PIC16(L)F19155/56/75/76/85/86

PIC16(L)F19155/56/75/76/85/86 Family Silicon Errata and Data Sheet Clarification

Data Sheet Clarifications

FIGURE 1: 28-PIN SSOP, SPDIP AND SOIC PIN DIAGRAM FOR PIC16(L)F19155/56

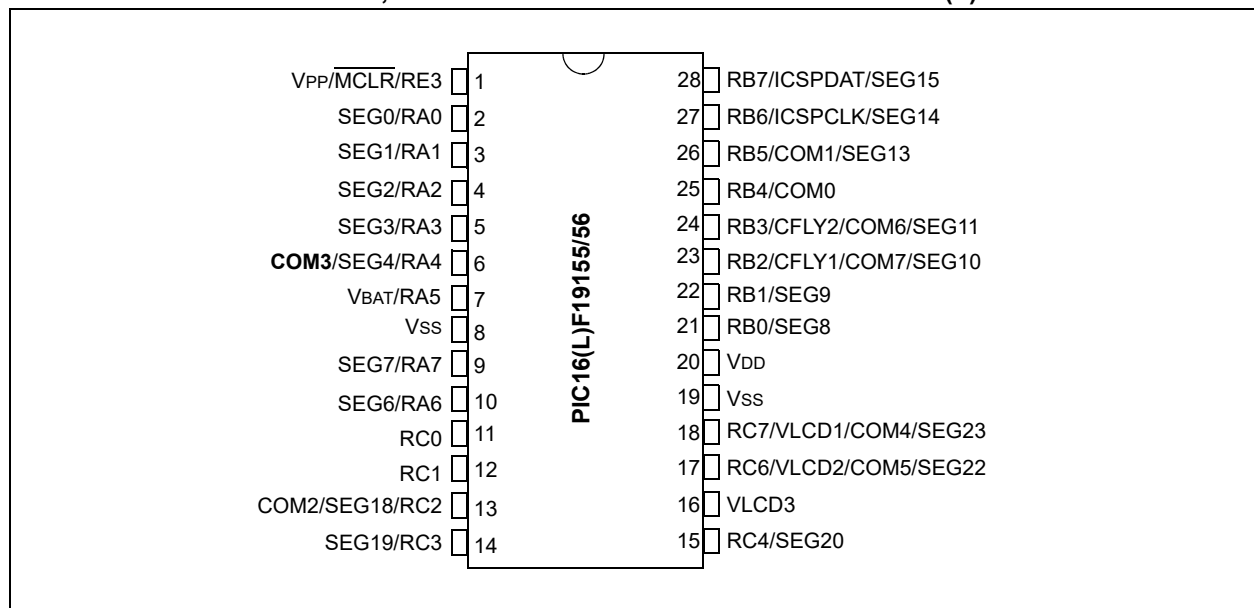
2.1 Pin Diagrams, Figure 1

The COM0 function multiplexed to RA4 is changed to COM3, as shown below.
